**Mount Owen  
Continued Operations Project**  
ENVIRONMENTAL IMPACT STATEMENT

**Response to Submissions**  
REPORT A: NSW Agency and Community Submissions

REPORT A:  
NSW Agency and Community Submissions

Project Director: **Barbara Crossley**  
Project Manager: **David Holmes**  
Report No. **3109/R16/V4**  
Date: **June 2015**

FIGURE 4.1

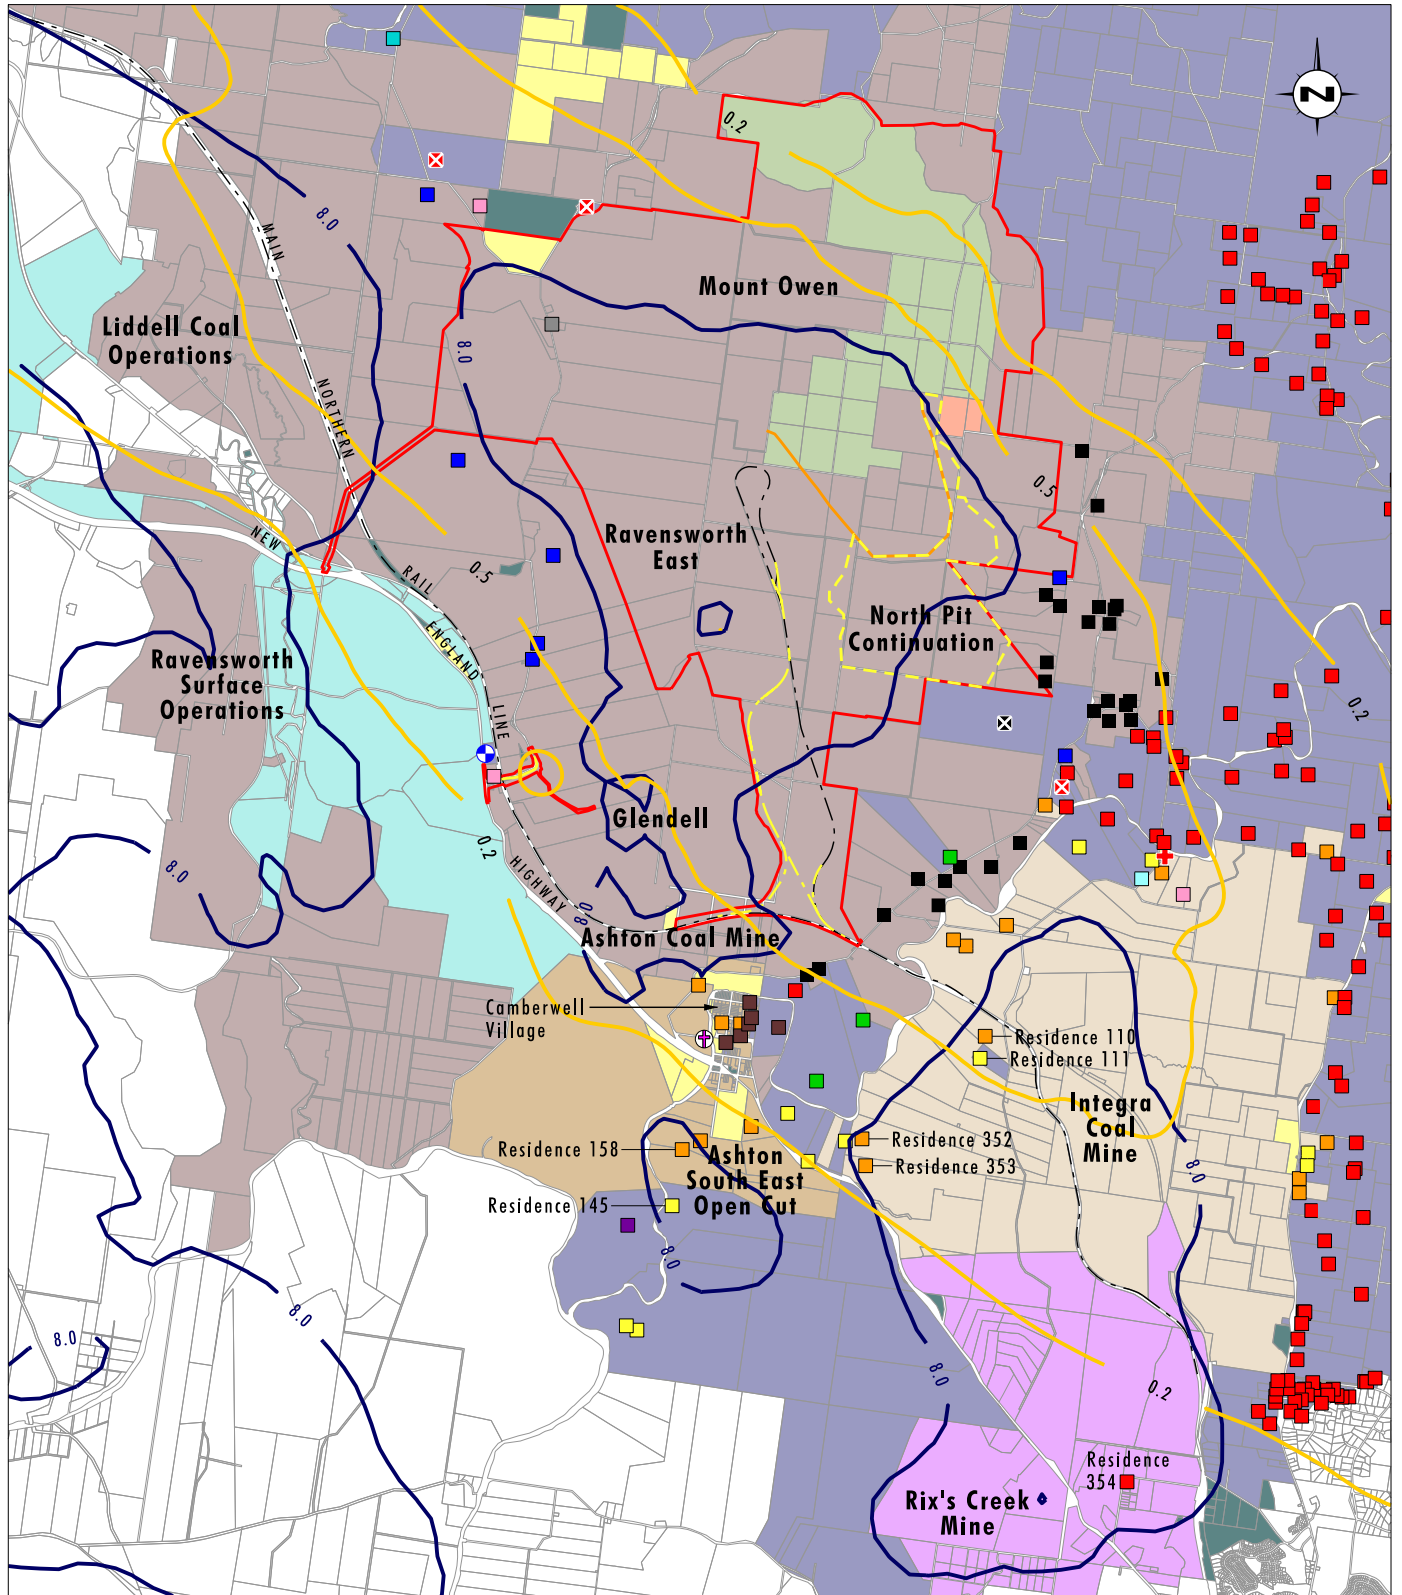
Following a review of the approach to cumulative modelling (refer to discussion below and **Appendix B**), the use of existing Camberwell PM<sub>2.5</sub> monitoring data for background was identified as contributing to a potentially significant over-prediction of cumulative PM<sub>2.5</sub> impacts as it resulted in a double counting of emissions from mining sources. **Appendix B** of this Report details the revised approach to modelling cumulative PM<sub>2.5</sub> annual average impacts. The revised approach uses background PM<sub>10</sub> levels derived from local and regional monitoring points which are less influenced by mining operations, and applies a ratio of PM<sub>2.5</sub>:PM<sub>10</sub> determined by analysing measurements from co-located PM<sub>2.5</sub> and PM<sub>10</sub> monitors from the EPA monitoring network. This method has been used in previous assessments in the area. This PM<sub>2.5</sub> background is then added to the modelled impacts from the Project and non-mining sources.

**Figure 4.1** shows the results of the revised calculations of predicted annual average PM<sub>2.5</sub> concentrations for Year 1 (the worst case for cumulative PM<sub>2.5</sub> assessment). The blue contour represents the predicted annual average PM<sub>2.5</sub> concentrations from all sources (including the Project and all other mining and non-mining sources); all areas within the contour are predicted to have annual average levels of PM<sub>2.5</sub> exceeding 8 µg/m<sup>3</sup> (the annual average ARS) based on conservative assumptions.

The yellow contours in **Figure 4.1** illustrate the predicted Project contribution to annual average PM<sub>2.5</sub> levels and **Table 4.1** sets out the properties where there is a predicted exceedance of the PM<sub>2.5</sub> annual average ARS (8 µg/m<sup>3</sup>) and the Project's contribution to impacts at these locations. The data in **Table 4.1** updates the PM<sub>2.5</sub> predictions provided in Tables E1 and E2 of the AQIA for these properties.

It can be seen from **Figure 4.1** and **Table 4.1** that concentrations at the levels of predicted impact from the Project alone (<1 µg/m<sup>3</sup> at all private residences in all modelled years) are well within the margin of error of any conventional instrumentation used to measure PM<sub>2.5</sub> and hence, any change in PM<sub>2.5</sub> levels due to the Project is likely to be undetectable.

FIGURE 4.2

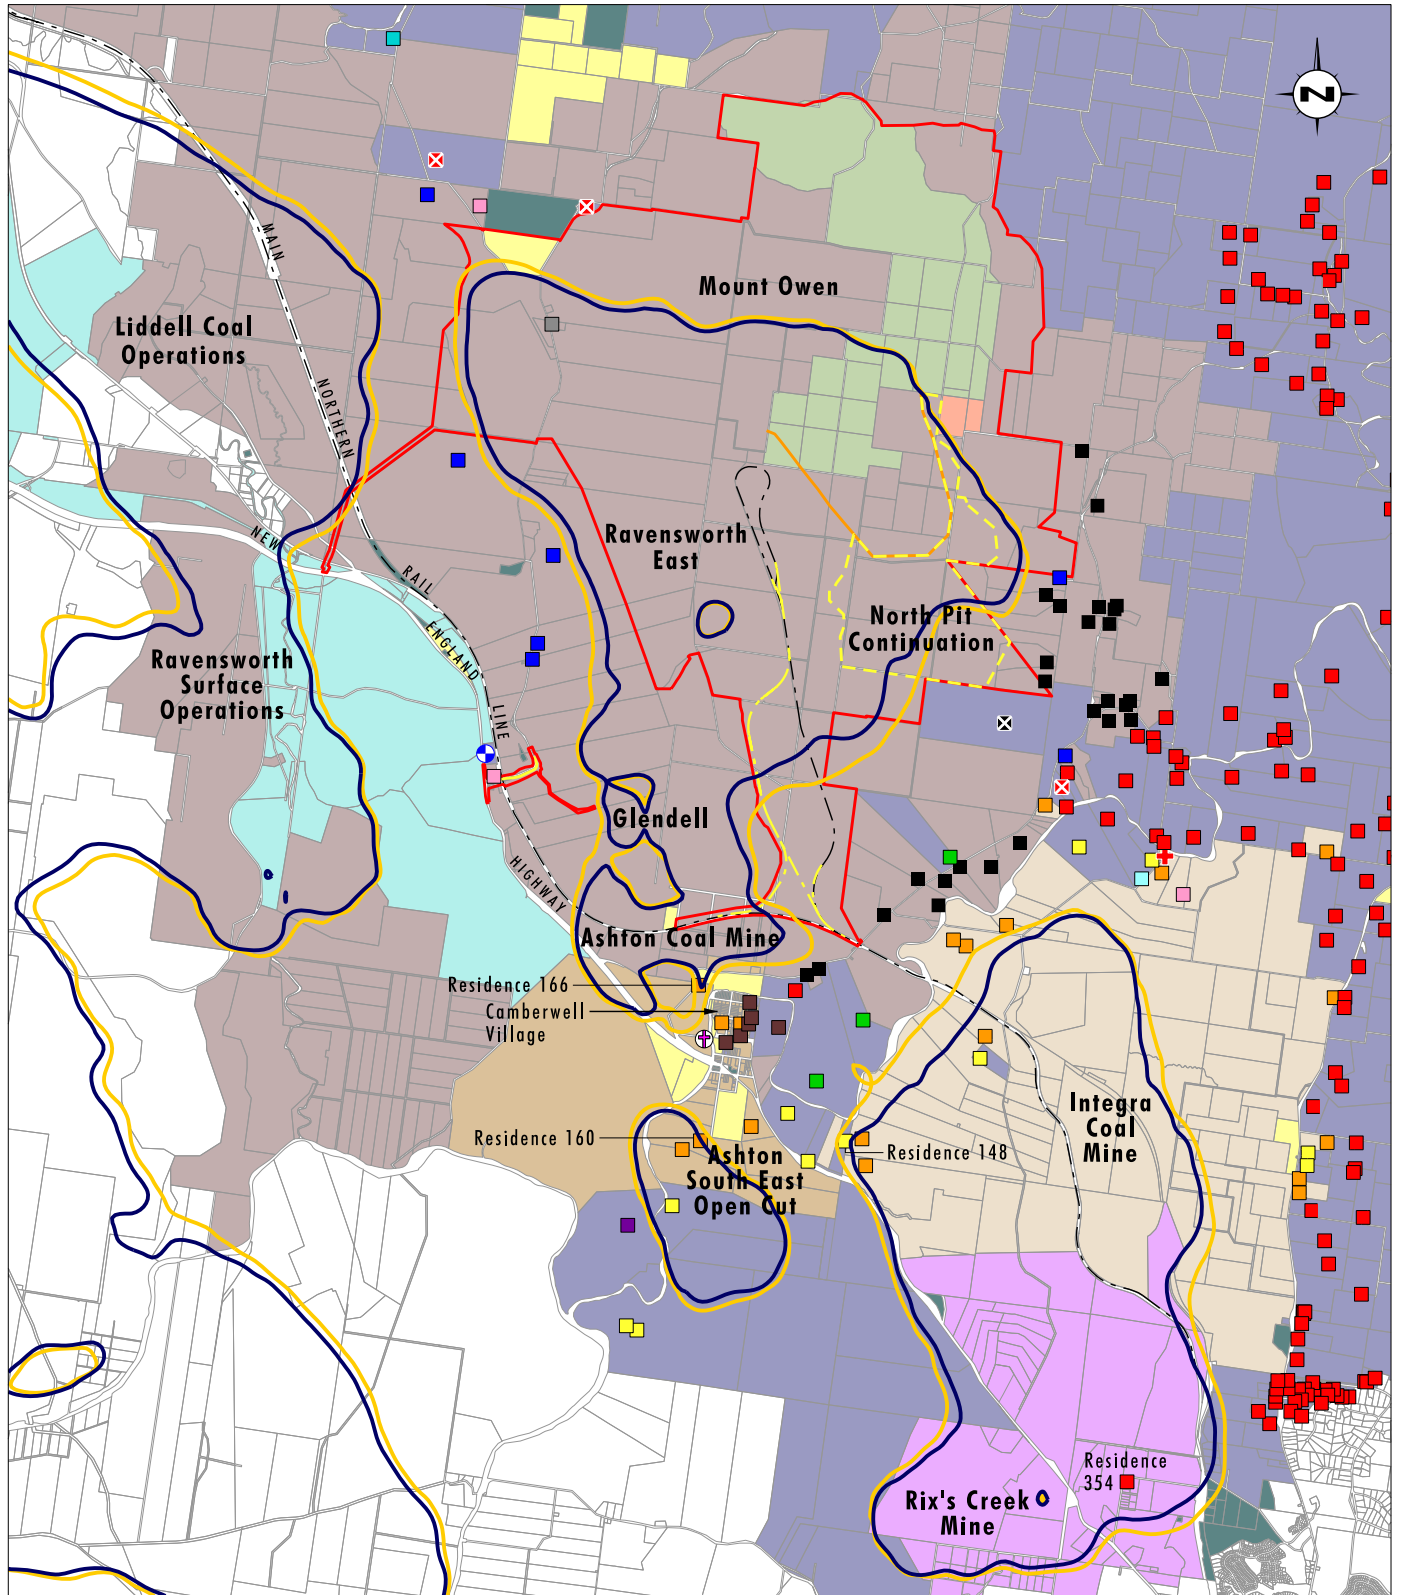
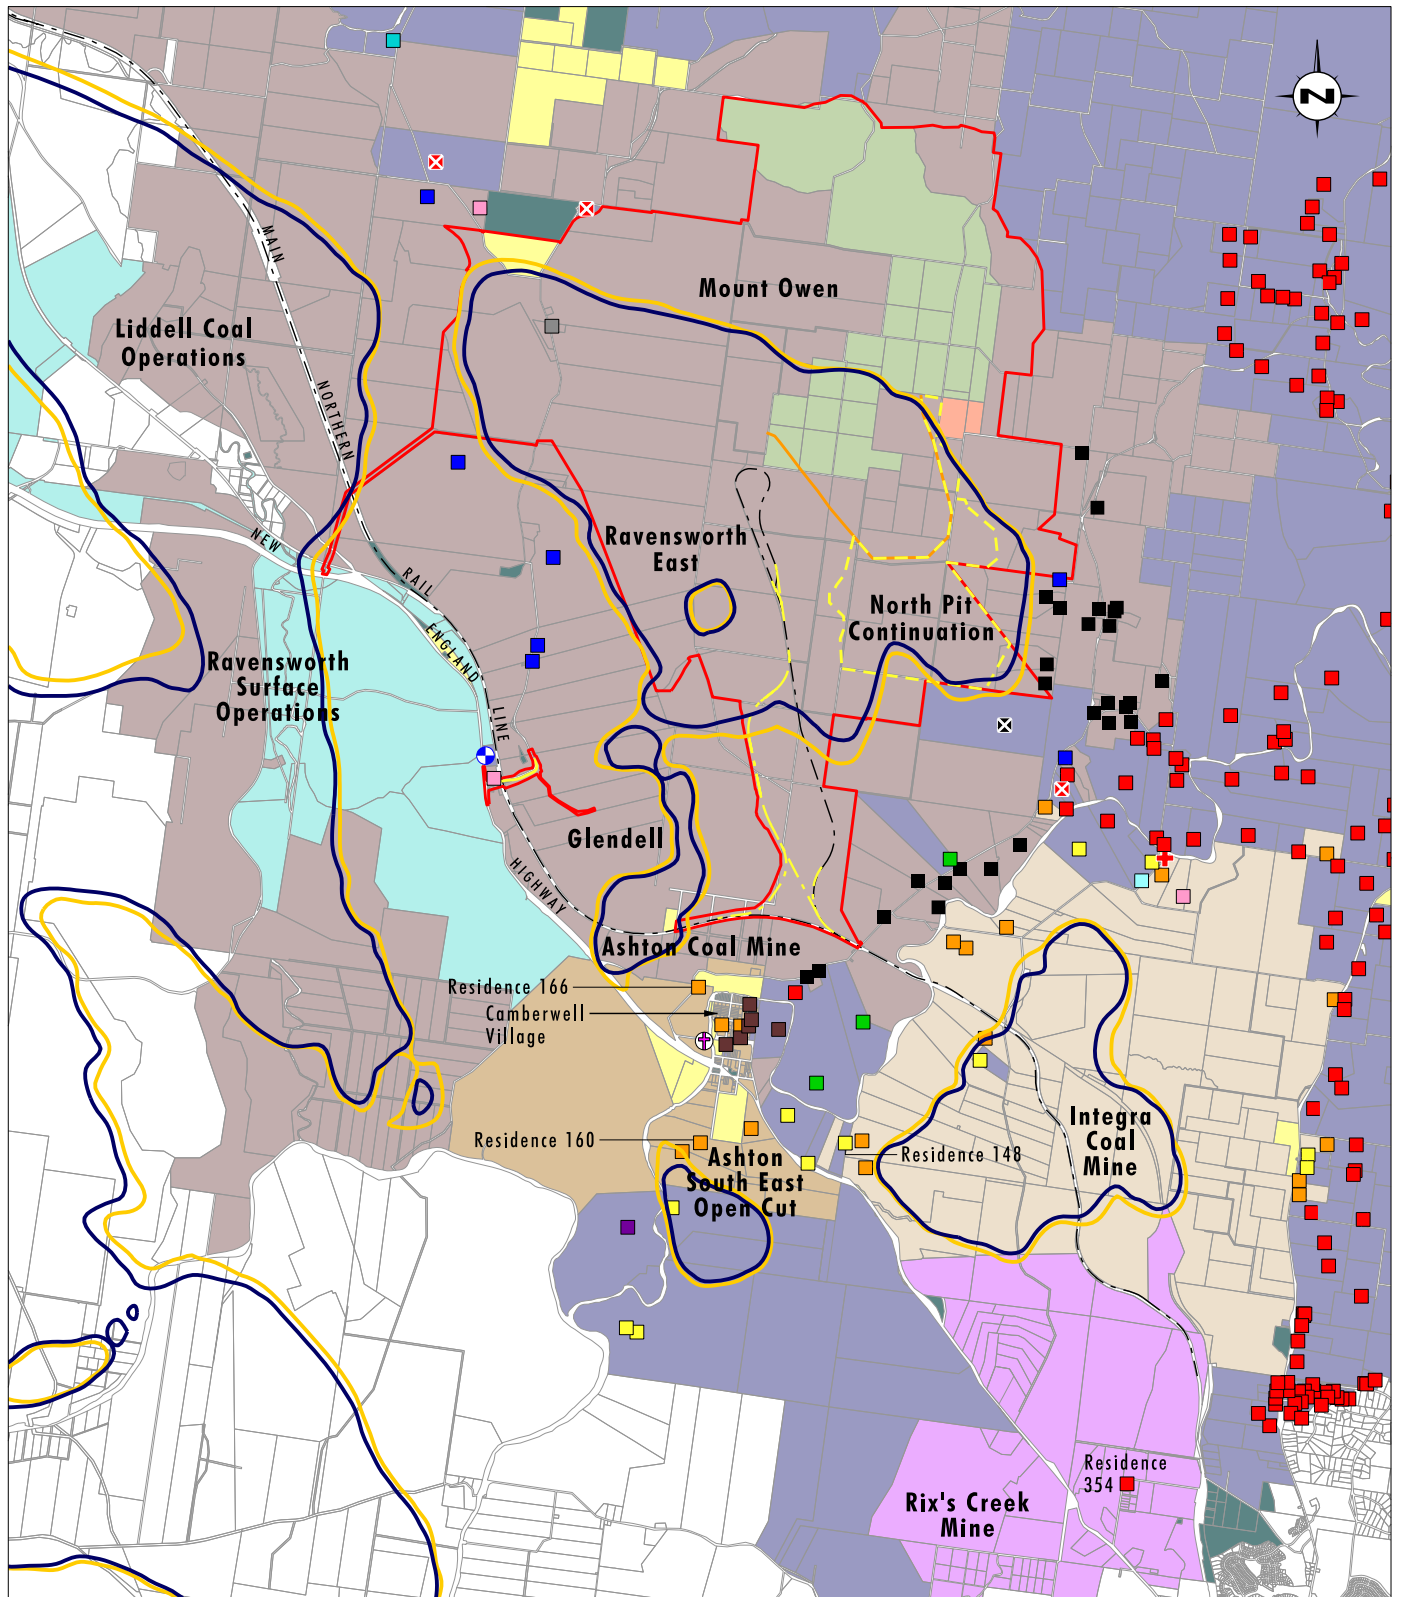
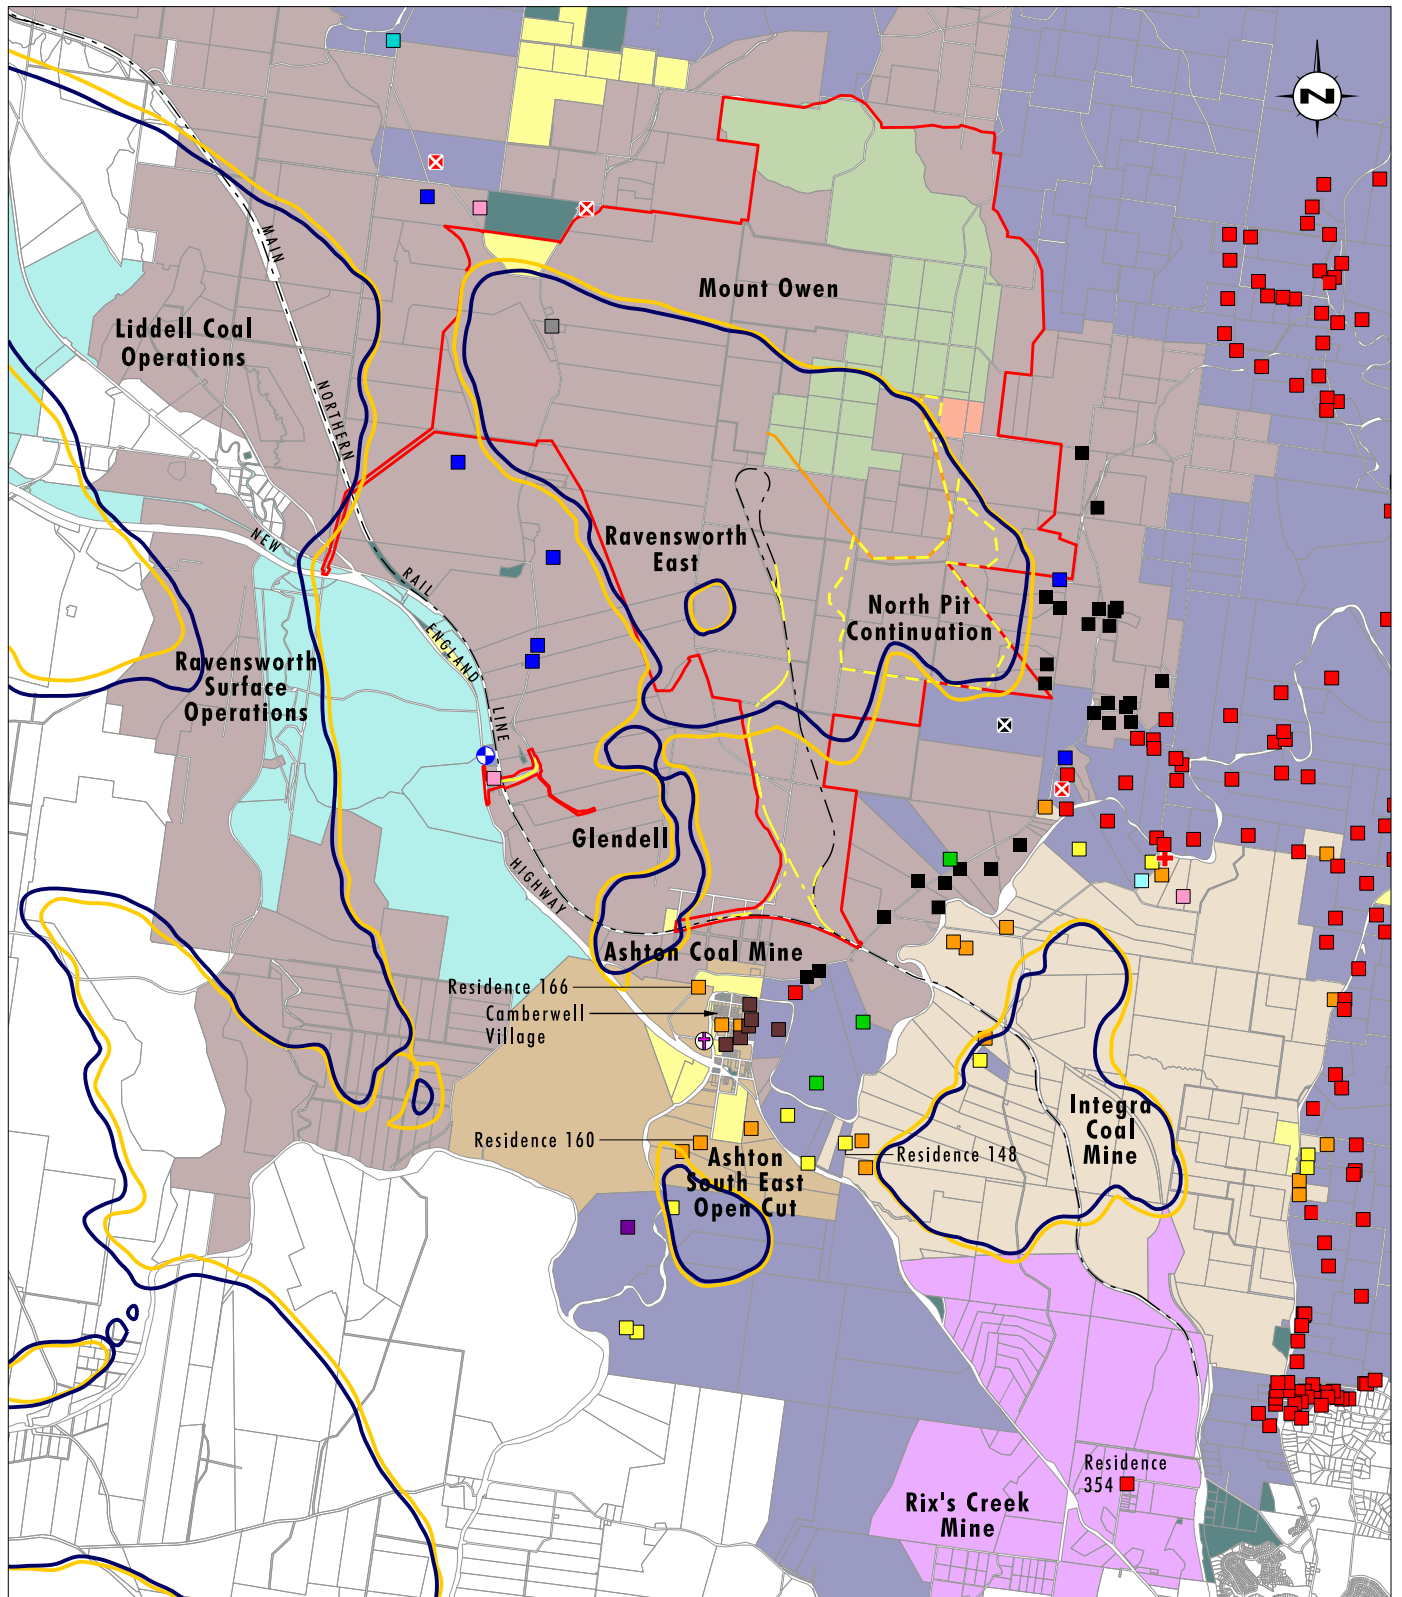
***The adopted annual average PM<sub>10</sub> background value appears low (13.2 µg/m<sup>3</sup>), noting that this PM<sub>10</sub> value is less than 50% of the adopted PM<sub>2.5</sub> background value in a region where ambient air quality is likely to be predominantly influenced by major PM<sub>10</sub> emission sources. Further, the dataset used to devise the annual average PM<sub>10</sub> background has been analysed in a manner that reduces the influence of extreme values without sufficient justification.***

Air quality in the region is predominantly influenced by major PM<sub>10</sub> emission sources (such as mining). A considerable amount of data analysis was therefore undertaken to estimate the non-mining contributions and this analysis, and the process of determining background PM<sub>10</sub> concentrations, is discussed in Sections 5.3 and 8.5 of the AQIA.

The background PM<sub>10</sub> levels referred to are only used in the modelling of cumulative annual average impacts. Cumulative annual average concentrations are determined by adding together modelled impacts from the Project, modelled impacts from other mining sources and background levels. The use of background data that had minimal influence from mining sources, yet was indicative of other background contributions from other sources in the region, was therefore necessary to avoid a double counting of mining related emissions in the assessment.

In determining PM<sub>10</sub> background levels, monitoring data (specifically from the UHAQMN) were analysed and those monitors which were less influenced by mining, either due to distance or relative location, were considered to be representative of what the background levels might be (in the absence of mining). Data from the Jerrys Plains, Wybong and Merriwa UHAQMN monitoring stations meet the selected criteria for background levels although it was recognised that the data from these stations would contain some contribution from mining sources. This selection process is discussed further in **Appendix B**.

The median value of 13.2 µg/m<sup>3</sup> has been used in the assessment. As discussed in **Appendix B**, the annual mean for the same period is 14.9 µg/m<sup>3</sup>. **Figures 4.2, 4.3 and 4.4** show the extent of the annual average PM<sub>10</sub> criterion contour, using both the median (dark blue line) and the mean (yellow line). In the worst case year (Year 1), three additional residences are predicted to exceed the 30 µg/m<sup>3</sup> criteria if the mean, rather than the median, is used. Two of these, R166 and R160, are already mine owned. The third, R148, is privately owned but has existing acquisition rights under the Integra project approval due to predicted noise impacts.
